Access Compliance Report Public Rights-of-Way (Curb Ramps)

Main Street: MAIN_ST Cross Street: CHIMNEY_LN Location: SE

ADA ID: RPRK211101131514 Ramp Type: Type 4 - Parallel Initial Pass/Fail: Fail Overall Compliance: No Severity Score: 30

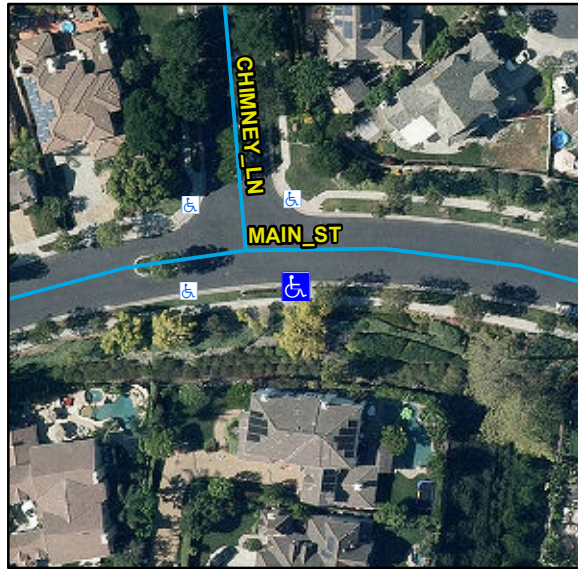
Compliance	Description	Data	Compliance	Description	Data
N/A	Ramp Length LT (in)	70	N/A	Ramp Length RT (in)	72
Yes	Ramp Width LT (in)	67	Yes	Ramp Width RT (in)	67
Yes	Ramp Run Slope LT (%)	1.9	Yes	Ramp Run Slope RT (%)	6.9
No	Ramp Cross Slope LT (%)	5.3	No	Ramp Cross Slope RT (%)	7.6
N/A	Landing Present	N/A	N/A	DWS Provided	N/A
N/A	Landing Length (in)	N/A	N/A	DWS Contrast	N/A
N/A	Landing Width (in)	N/A	N/A	DWS Length (in)	N/A
N/A	Landing Run Slope (%)	N/A	N/A	DWS Full Width	N/A
N/A	Landing Cross Slope (%)	N/A		DWS Offset Type	N/A
N/A	Landing Movement Obstructed?	N/A	N/A	DWS Offset Left (in)	N/A
	Landing Movement Type	N/A	N/A	DWS Offset Right (in)	N/A
N/A	Landing Shared	N/A			
N/A	Clear Space	N/A			
N/A	Clear Space To Crosswalk (in)	N/A			
N/A	Marked Crosswalk 1	No	N/A	Marked Crosswalk 2	N/A
	Crossing 1 Direction	N		Crossing 2 Direction	N/A
	Marked Crosswalk 1 Width (in)	N/A		Marked Crosswalk 2 Width (in)	N/A

Remove & Replace Entire Ramp.

R304.5.3, STD 1115
